**Office of Legacy Management Response to U.S. Nuclear Regulatory Commission's
October 30, 2019, Comments and Request for Additional Information**

*RE: Comments and Request for Additional Information, Draft Groundwater Compliance Action
Plan, Gunnison, Colorado, Processing Site
Docket No. WM-00061*

SUBJECT: GUNNISON, COLORADO, PROCESSING SITE – REQUEST FOR
ADDITIONAL INFORMATION RE: DRAFT GROUNDWATER COMPLIANCE
ACTION PLAN

Figure 7. Uranium Trend in MW0067 and MW0082 vs. Applicable uranium standard (0.044 mg/l)

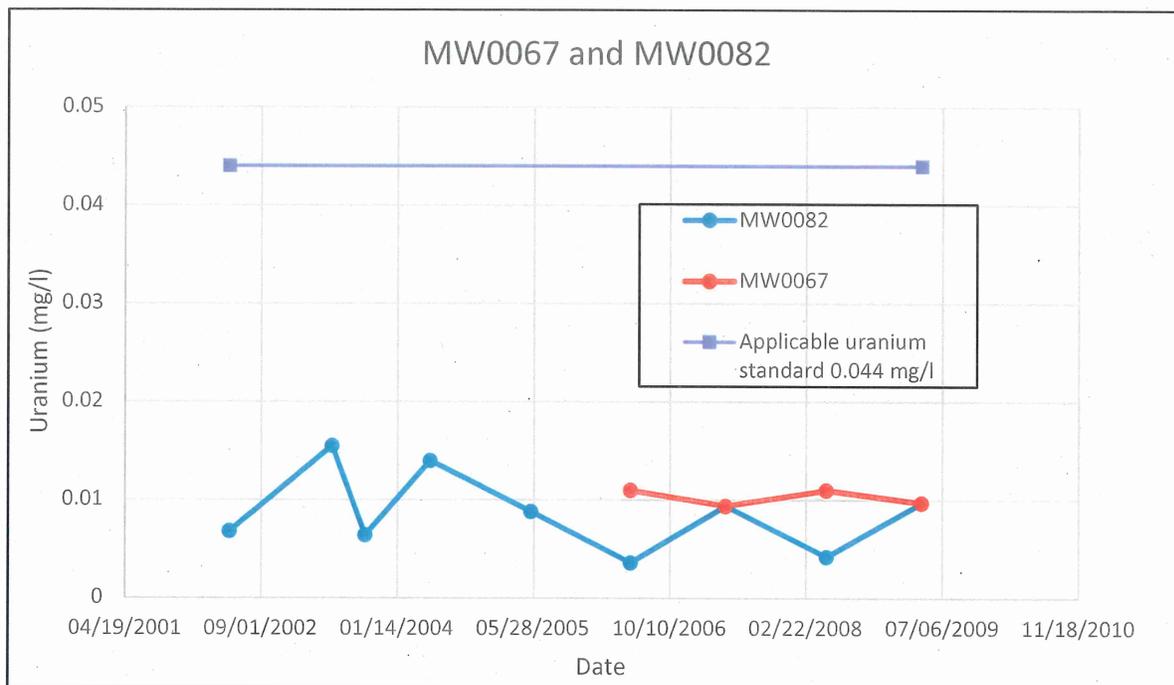
NRC staff finds groundwater must be suitable for unrestricted use downgradient of a revised Sector 2 as there are no ICs beyond this boundary. DOE measured uranium concentrations in private domestic wells MW0080, MW0081, and MW0082 just south of the Sector 2 gravel pit boundary in the past. Some of the uranium measurements in these domestic wells were elevated relative to background, but below the applicable uranium standard of 0.044 mg/l. In 2005, DOE installed MW0067 shown on Figure 5 to verify elevated uranium concentrations measured in

private domestic well MW0082 were representative. DOE monitored MW0067 for four years as shown in Figure 7 below.

DOE has not provided any uranium measurements in MW 0067 since 2008. To concur on an ACL for the recommended revised Sector 2, NRC staff must have an analysis that demonstrates that domestic groundwater users south of the IC boundary for a revised Sector 2 will not be exposed to uranium levels above the applicable standard of 0.044 mg/l.

Path Forward: NRC staff requests that DOE provide an analysis to support the conclusion that uranium concentrations in the alluvial aquifer will not exceed the applicable uranium standard of 0.044 mg/l beyond the IC boundary south of the gravel pit operations in a revised Sector 2. This information should include updated modeling with recent site monitoring data as well as additional groundwater monitoring data beyond the IC Boundary to the south and west of the former processing site in Sector 1. NRC staff also requests that DOE add a POE well, such as MW0067, if it still exists or install a new POE well in this area to verify that the proposed ACL for Sector 2 is protective of private well users.

Response	LM Comment Response	LM Comment Basis Response	LM Approach to Comment
	LM acknowledges NRC's Comment 6 that a POE well is needed to the south of the IC boundary and agrees that if it is determined there is potential that unrestricted groundwater use in that area may pose a substantial present or potential hazard to human health and the environment, then a POE well and/or an expanded IC boundary may be necessary.	LM agrees with NRC that an evaluation of potential hazards from proposed ACLs must consider several factors, including potential adverse effects on groundwater quality including the proximity and withdrawal rates of groundwater users. If the original Sector 2 boundary or revised Sector 2 boundary is used, the need for a POE well or IC boundary would need to be evaluated.	LM concurs with NRC and will provide analysis of the areas to the south and west of the former processing site in Sector 1. The approach to address these areas will be based on initial review of existing data, identification of data gaps, and consideration of potential risks to human health and the environment. If it is found there is limited data and inherent risks in either of these areas, appropriate investigations and evaluations will be conducted to confirm the risk and POEs after defining the ACL sector boundaries.
